Subject: Byron Station Units 1 and 2
 Braidwood Station Units 1 and 2
 ATWS Protection - 10 CFR 50.62
 NRC Docket Nos. 50-454/455 & 50-456/457

Enclosed with this letter is Revision 6 to "ATWS Mitigation System Specific Design for Byron/Braidwood Stations". Revision 6 describes the changes made to hardware based on the selection of a new vendor to supply the system. (The software design remains the same.) These were discussed in a teleconference held on February 9, 1989 between Commonwealth Edison personnel and the NRC staff.

Specific Changes to Revision 6 of the
ATWS Mitigating System Specific Design
for Byron/Braidwood Stations
Commonwealth Edison Company

ATWS Mitigation System Specific Design
for Byron/Braidwood Stations
Commonwealth Edison Company. Revision 6

FIGURE 3-1

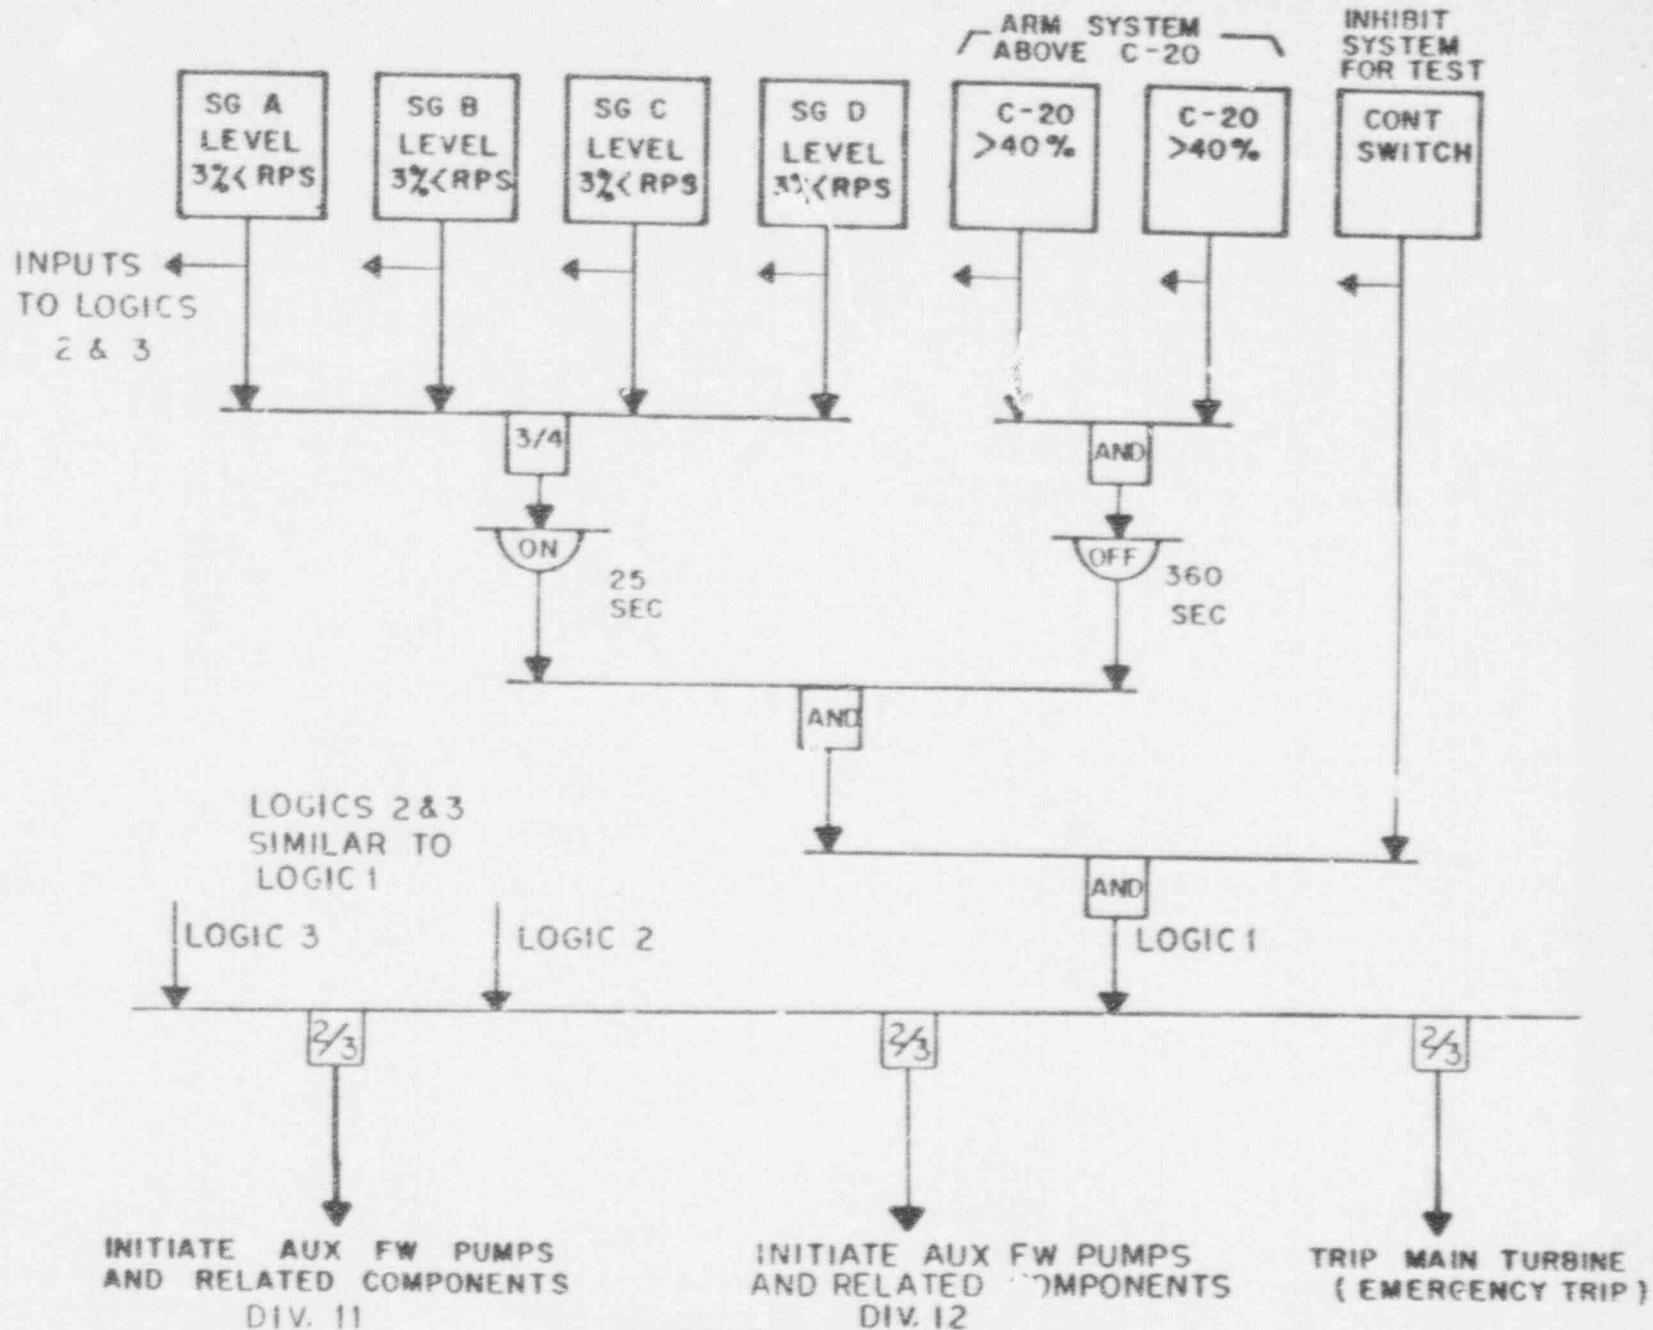
<u>REVISION 5 PAGE NO.</u>	<u>REVISION 5 SUBMITTAL</u>	<u>REVISION 6 PENDING SUBMITTAL</u>	<u>REASON FOR CHANGE</u>
3-1& 3-2		Added statement about the SAIC equipment's 2-out-of-3 logic coincidence to trip.	New feature to SAIC equipment that enhances reliability.
3-4	Inoperable alarm includes loss of power, AMS in test, and automatic bypass (C-20 < 40%).	Added "module removed." Deleted "automatic bypass" (C-20 < 40%).	Feature unique to SAIC system. This deletion is based on the philosophy that this "Inoperable" alarm should warn operators of "unsafe" and "abnormal" conditions. This bypass situation is a normal, operational design condition (similar to R.G. 1.47 status windows).
4-1	...Rosemount master trip unit...	SAIC (Science Applications International Corporation) bistable...	New hardware purchased with logic system - see below.
4-1	...Rochester Solid State Logic System or approved equivalent.	SAIC Solid State Logic System	Rochester no longer supplied the original specified hardware; thus, new vendors were investigated, and SAIC was chosen.

As shown in Figure 3-1, one AMS logic train with three logic subsystems is provided. Both the main turbine trip and auxiliary feedwater actuation signals are initiated by this logic train. For reliability, three redundant, identical logic subsystems are provided, and a two-out-of-three coincidence of these logic subsystems is required in initiate actuation.

Two-out-of-three coincidence of the logic subsystem trips will actuate the auxiliary feedwater system (i.e., motor driven and diesel driven auxiliary feedwater pumps and related equipment) and trip the main turbine (through the emergency trip). A time delay (approximately 25 seconds) is provided to ensure the reactor protection system will provide the first trip signal.
